LAYGOCK DE NORMANVILLE OVERDRIVE

SUPPLEMENTARY INSTRUCTIONS
FOR INCORPORATION OF
OVERDRIVE ON 2nd AND 3rd GEARS

TRIUMPH SPORTS CAR

PUBLICATION PART No. 502123/SI

FIG.I

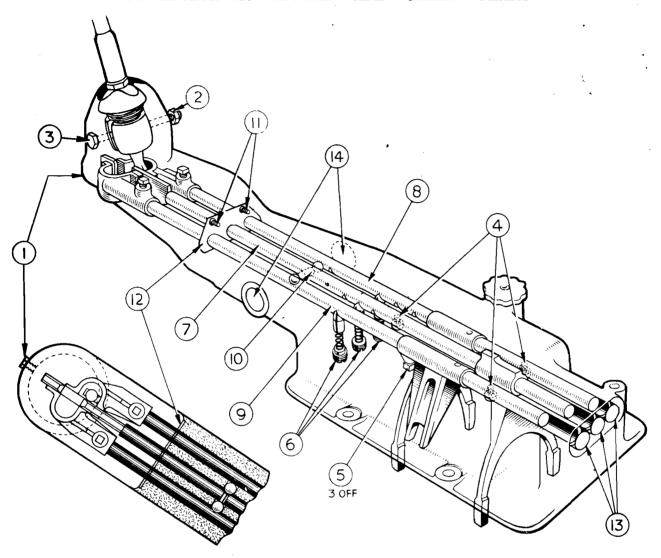
- The incorporation of Overdrive on "Second" and "Third" gears has necessitated the following engineering alterations:—
 - (a) Increasing the diameter of the clutch operation pistons in the overdrive unit from $1\frac{1}{8}$ " to $1\frac{3}{8}$ ".
 - (b) Re-designing the gearbox top cover assembly to permit the selection of overdrive in other gears.

To permit the selection of overdrive in "Second" and "Third" as well as "Top" a new top cover assembly has been designed and the Part No. is 502411.

Modification of Top Cover Assembly. To modify the old top cover assembly, thus permitting the selection of overdrive in 2nd, 3rd and top gears necessitates the fitting of certain new parts. The new parts required are detailed under "Top Cover Conversion Pack" on page 4.

Top Cover Assembly—Fig. 1—Dismantling. Proceed as follows:—

- (a) Remove the dipstick and ensure that the selector mechanism is in the "Neutral" position.
- (b) Disconnect the wires from the isolator switch, where fitted, and remove the top cover assembly from the gearbox.
- (c) Remove the change speed lever by:—
 (i) Unscrewing and removing the ½" UNF setscrew (1) which secures the retaining cap to the top cover casting.
 - (ii) Unscrewing the nyloc nut (2) from the pivot bolt.

- (iii) Withdrawing the pivot bolt (3) to enable the change speed lever assembly to be withdrawn.
 - Caution. When withdrawing the change speed lever assembly, ensure that the anti-rattle spring and retainer, which is located on the spherical part of the lever, is retained for re-assembling.
- (d) Remove the three wire locked stop screws (4).
- (e) Unscrew and remove the three wire locked screwed taper pins (5) securing the forks to the selector shafts.

Top Cover Assembly—Fig. 1—To Assemble. Assemble the new selector forks into the new top cover by reversing the dismantling procedure, observing the following:—

- (a) Ensure before fitting the centre selector shaft that the interlock pin is positioned in the end of the shaft. (See 10).
- (b) After fitting and moving the centre shaft to the "Neutral" position, feed the two interlock balls into position from either side. (See 10).
